**TAMPA-HILLSBOROUGH COUNTY  
EXPRESSWAY AUTHORITY**

**Letter of Clarification No. 2**

**TWIGGS STREET IMPROVEMENTS  
DESIGN-BUILD PROJECT**

**RFP O-00820**

**ROADWAY PLAN (01)**  
**TWIGGS ST**

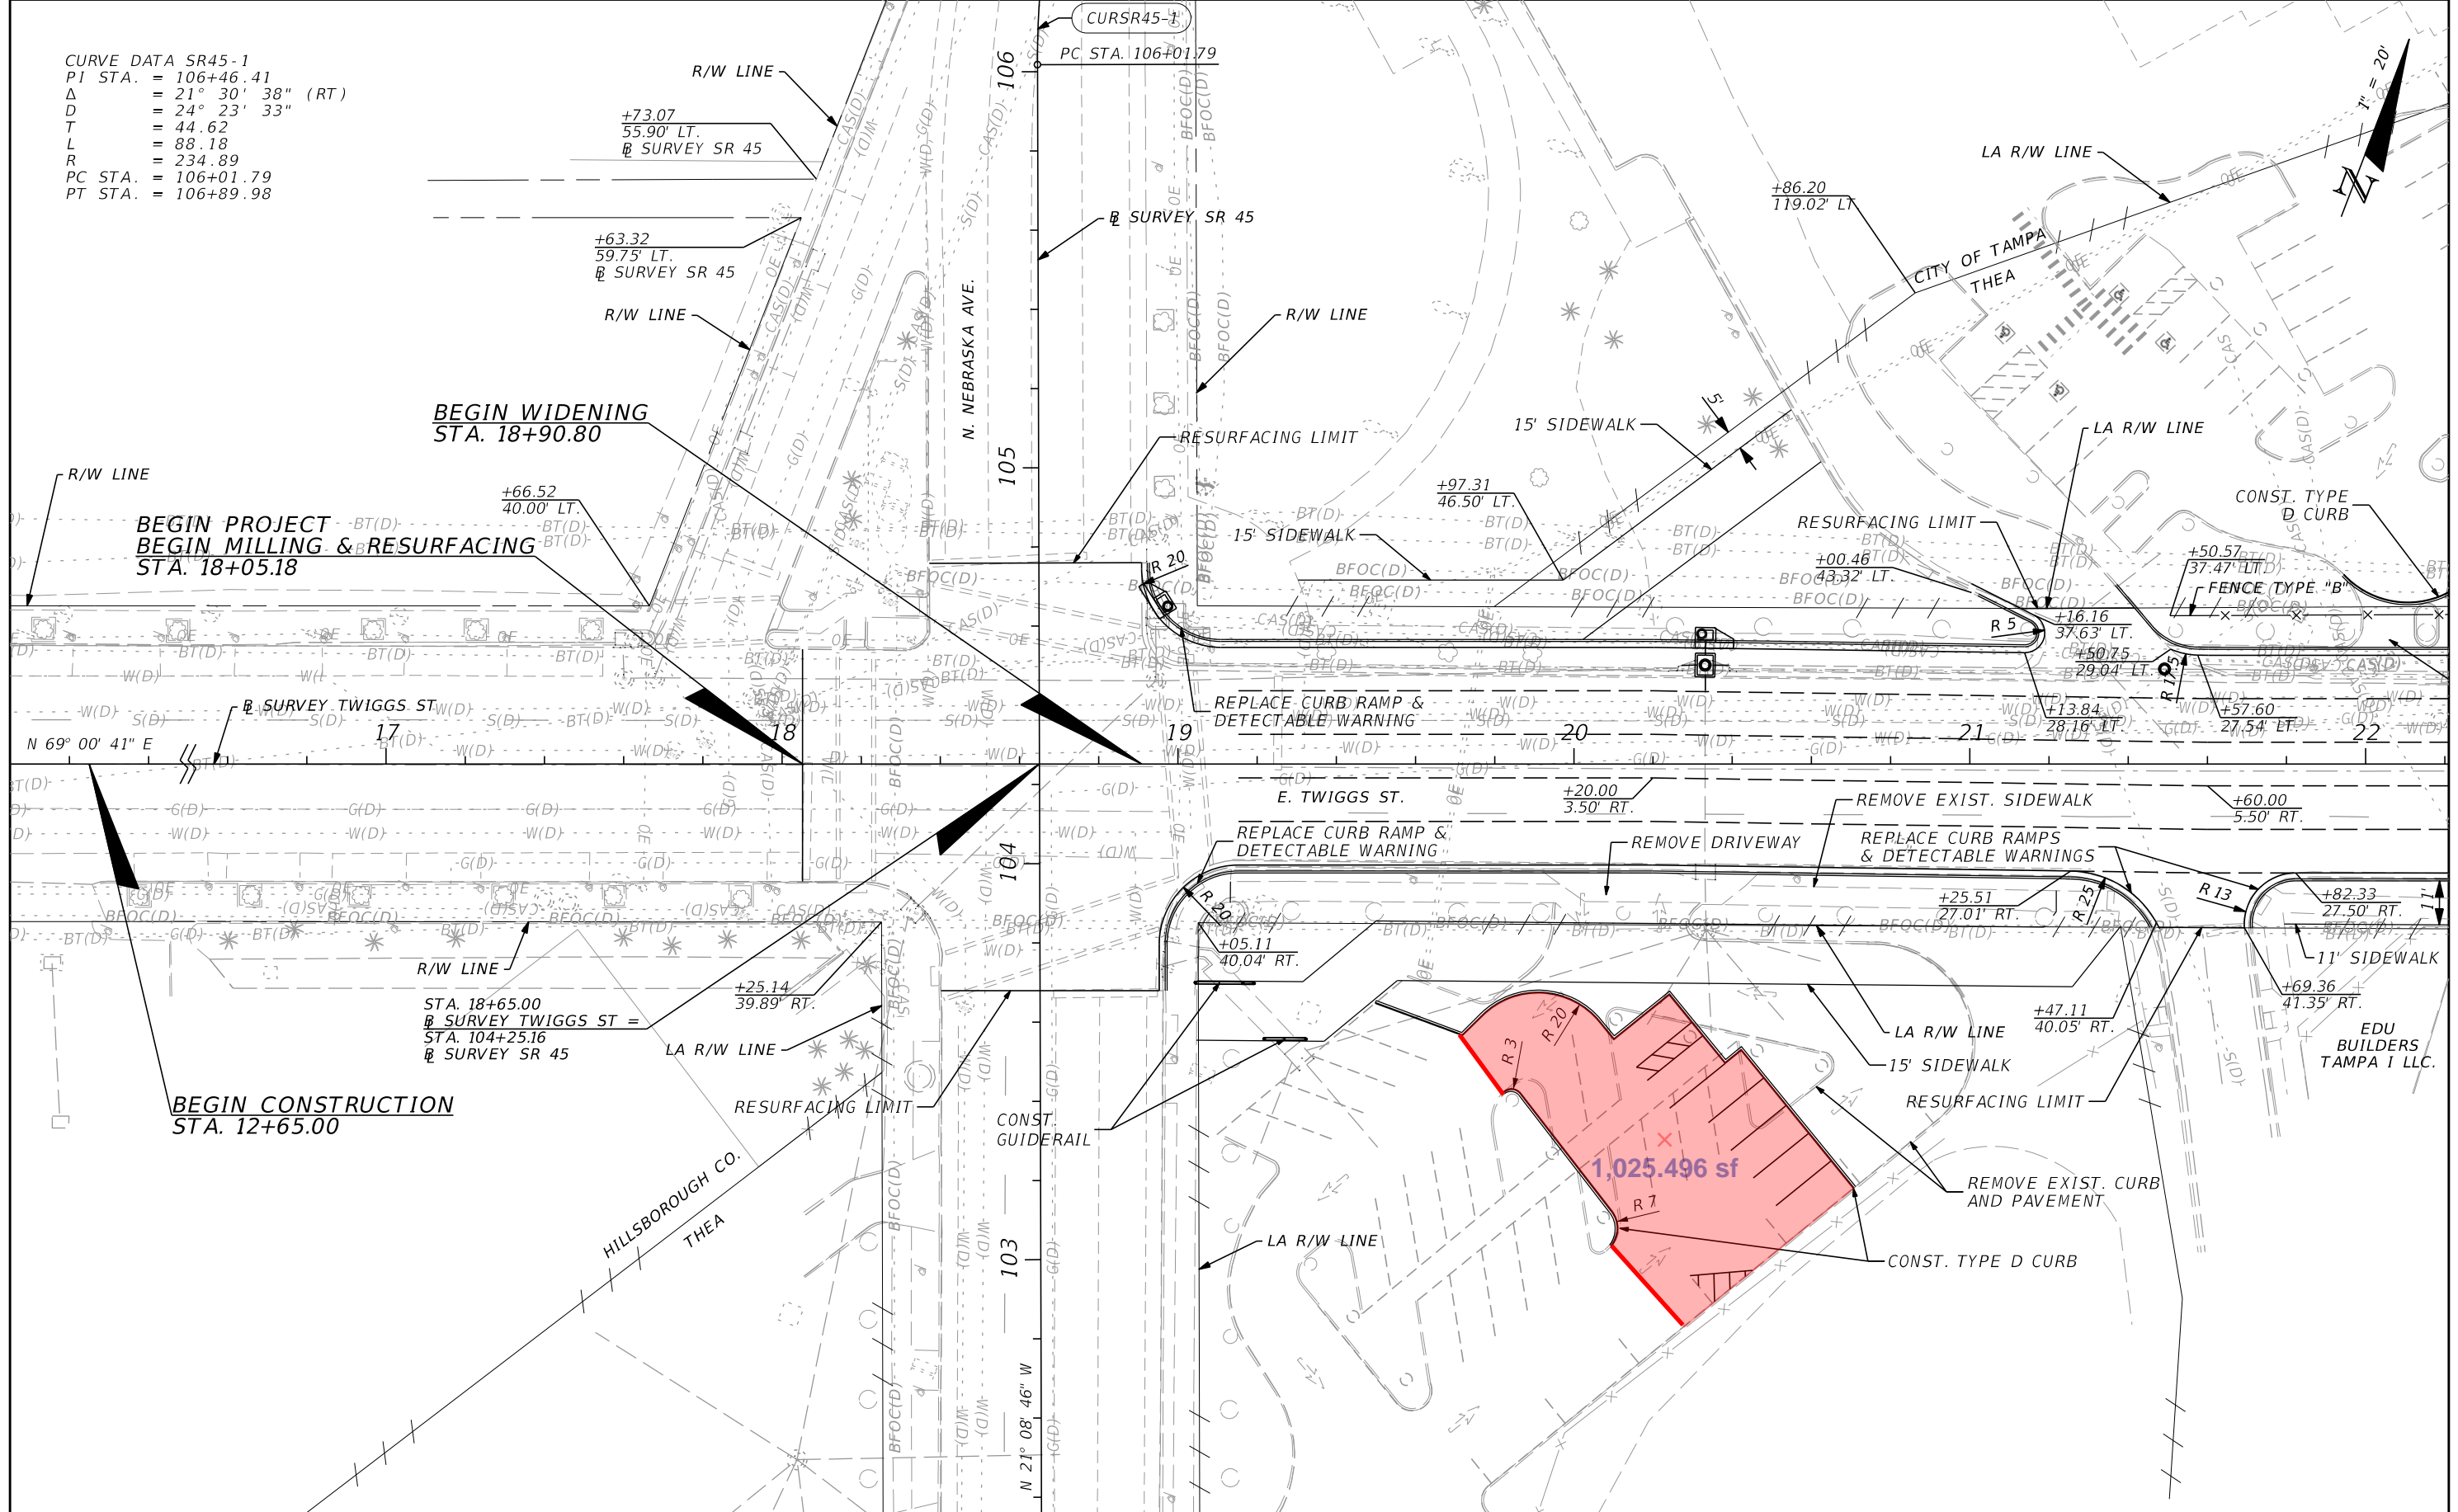
Question 8:	Can the Authority please identify the minimum limits of resurfacing for the parking lot improvements?
Response 8:	<b>The minimum limits of parking lot resurfacing shall be bound by the inside curb line shown in the attached graphic.</b>

**Attachment to Response 8**

REVISIONS				TAMPA HILLSBOROUGH EXPRESSWAY AUTHORITY			TWIGGS ST AT NEBRASKA AVE	SHEET NO.
DATE	DESCRIPTION	DATE	DESCRIPTION	ROAD NO.	COUNTY	FINANCIAL PROJECT ID		
					HILLSBOROUGH		1

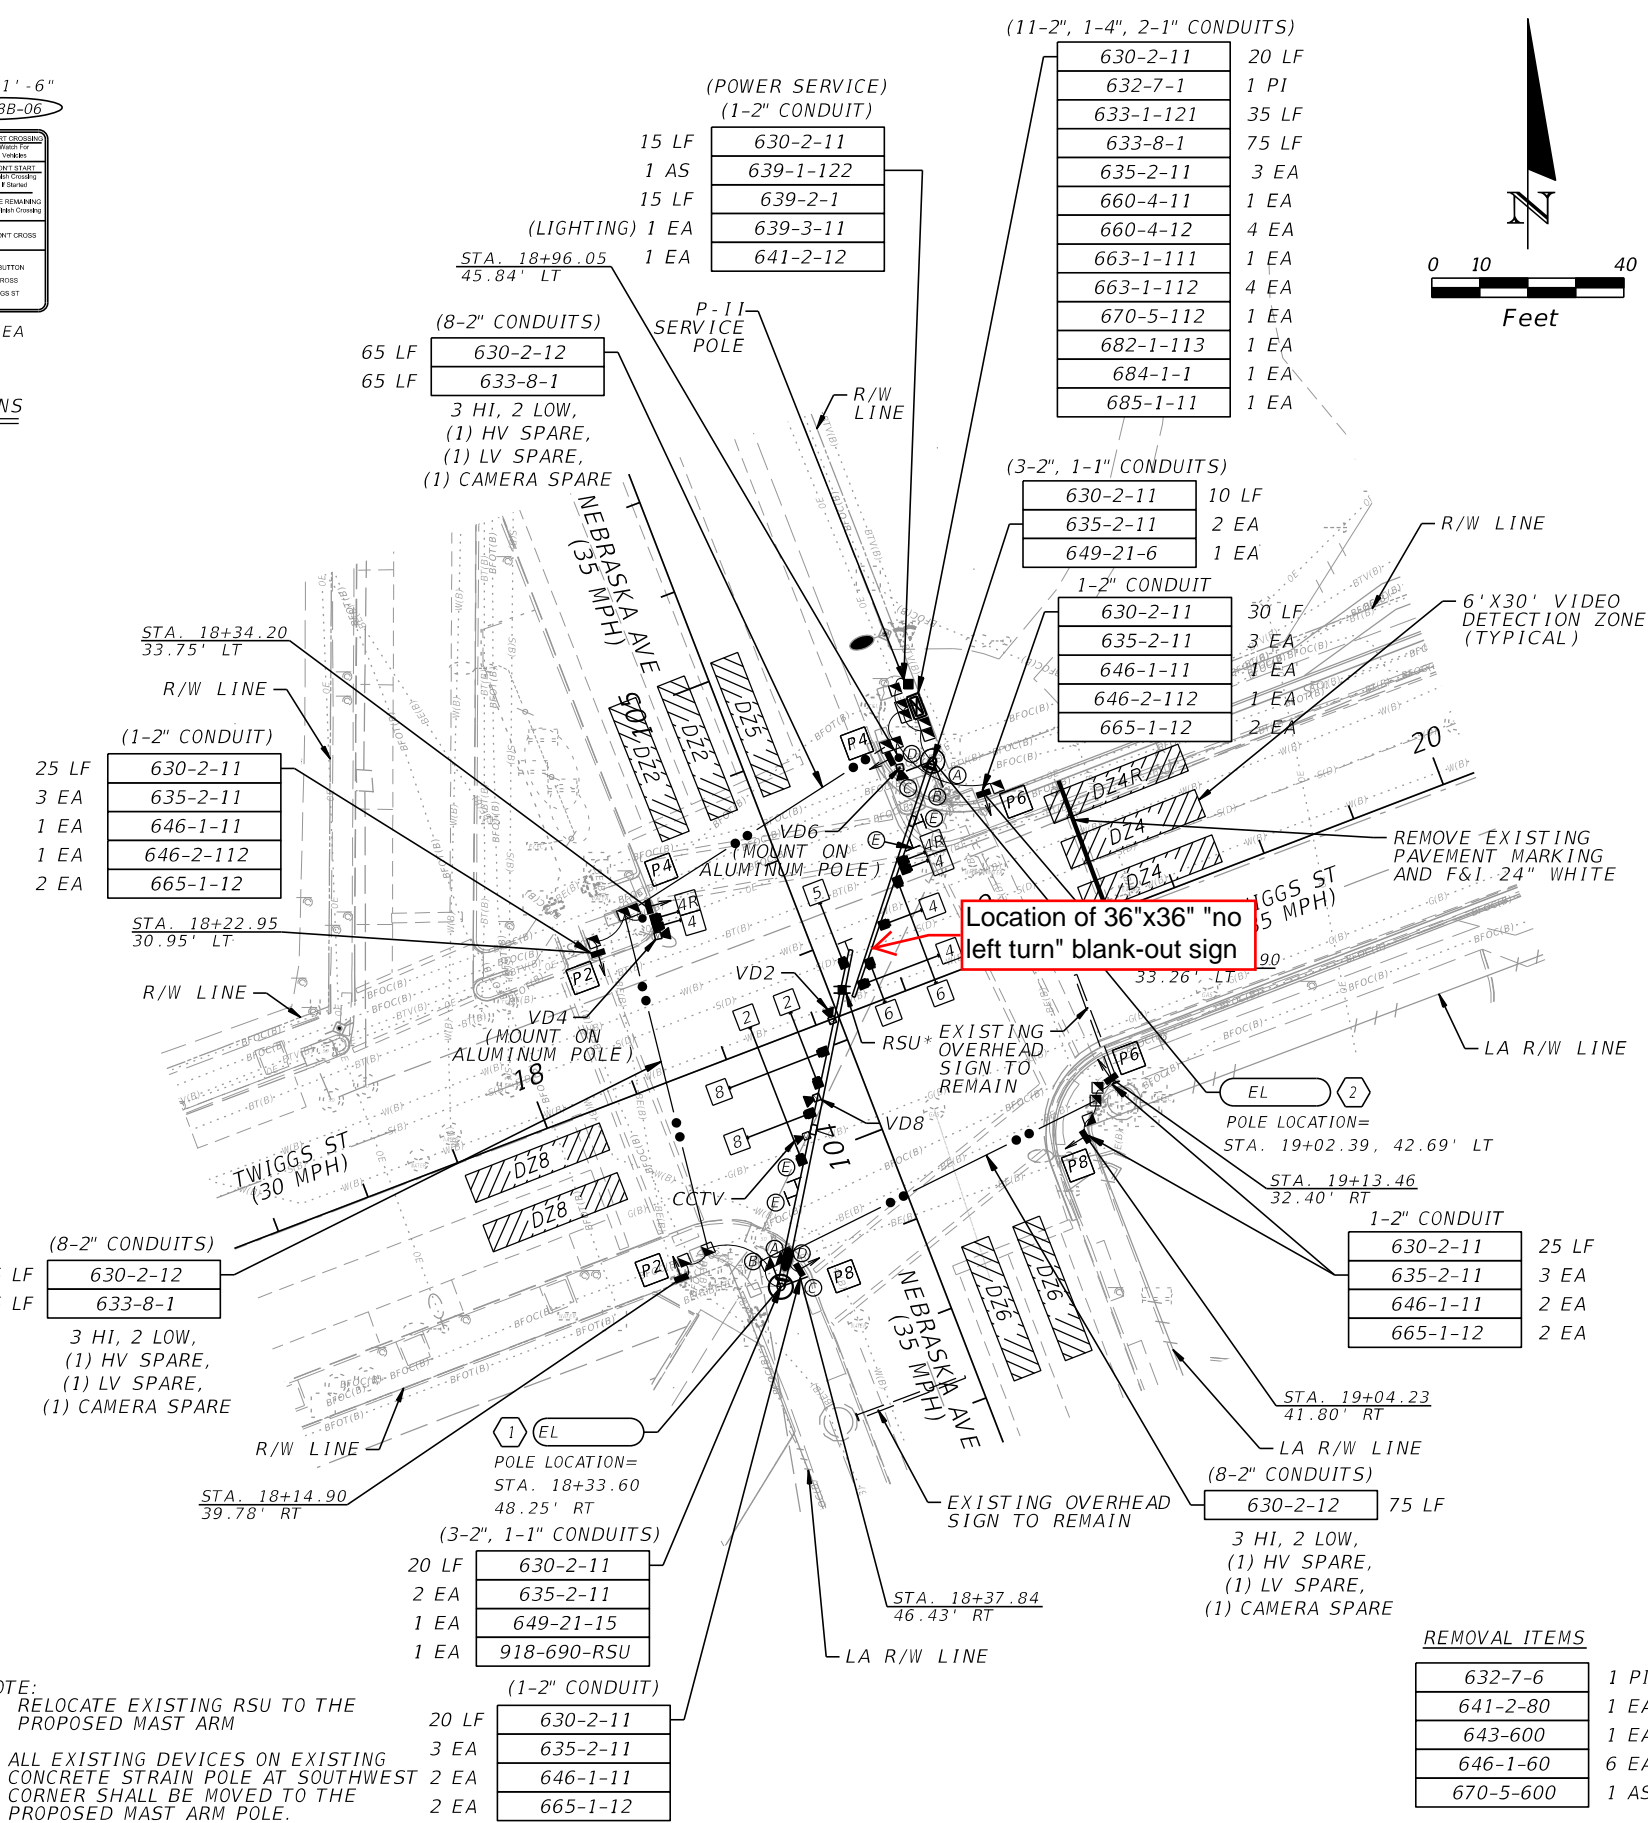
Question 10:	Can the Authority please provide the concept location and panel details for the overhead sign restricting westbound Twiggs Street traffic from turning left at Nebraska Avenue?

Response 10:	<p>Provide a 36”x36” R3-2 LED Blank-Out sign attached to the mast arm. The final location on the mast arm and vendor selection is the responsibility of the Design-Build Firm, however approximate location requirements and example cut sheets are attached.</p>

NOTE:  
\* RELOCATE EXISTING RSU TO THE PROPOSED MAST ARM  
\*\* ALL EXISTING DEVICES ON EXISTING CONCRETE STRAIN POLE AT SOUTHWEST CORNER SHALL BE MOVED TO THE PROPOSED MAST ARM POLE.
